Subject: Revised Certification Report Phase 2 Cell 1A
Greenway Waste Solutions at Apex, LLC
Permit No. 92-30
CEC Project No. 111-370

**CONSTRUCTION QUALITY ASSURANCE REPORT
PHASE 2 CELL 1A
REVISION 1**

**CONSTRUCTION AND DEMOLITION DEBRIS LANDFILL FACILITY
PERMIT No. 92-30**

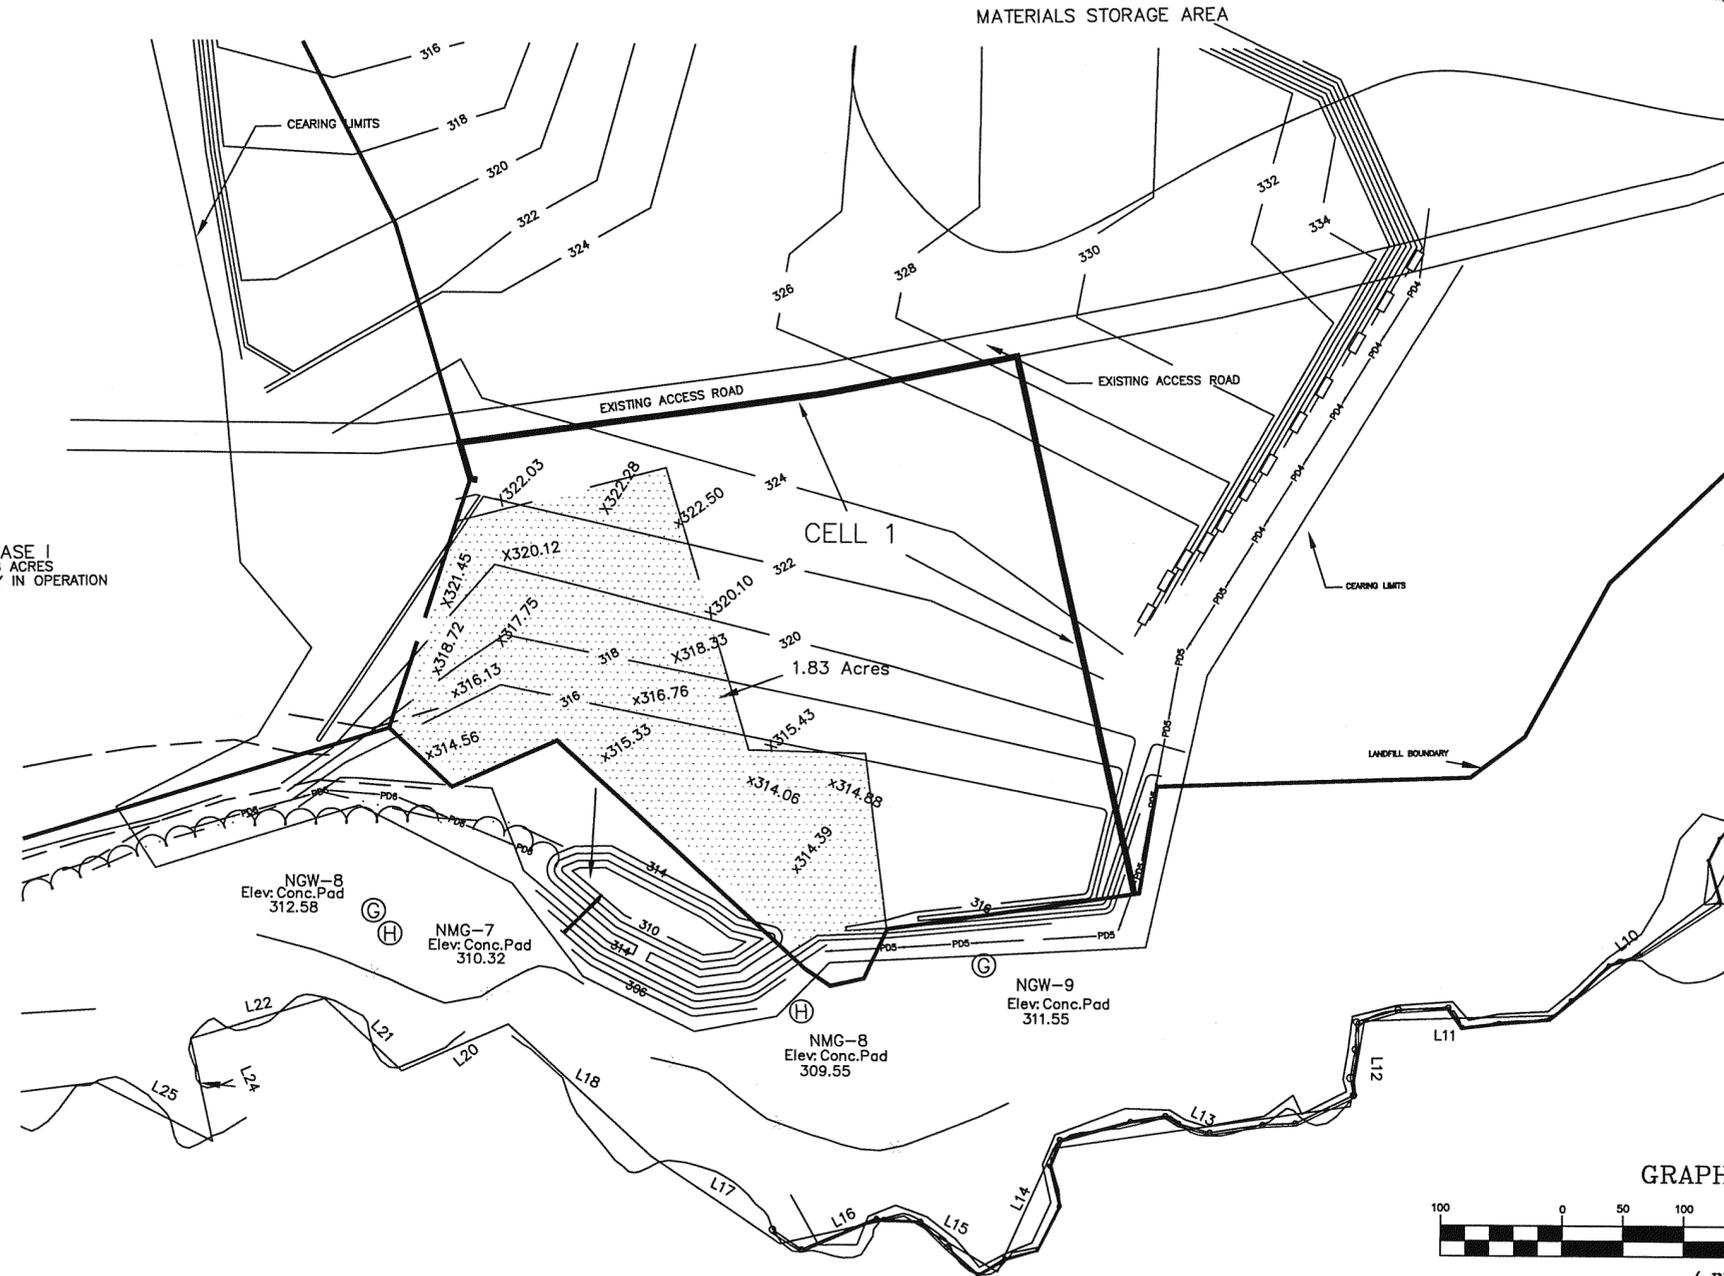
- 2. You certified Cell 1 of Phase 2. According to App. B the certified area is only a part of Cell 1 (Cell 1A would be appropriate).**

- 4. The record drawings shall be prepared to accurately locate the floor grade, surface water drainage features, haul roads and berms etc. If there are any changes in the location of the compost or any other auxiliary functions a new Facility Plan needs to be submitted within 30 days after permit issuance.**

Changed as noted.

Items addressed in the revised report. Auxiliary functions will be located per the Facility Plan.
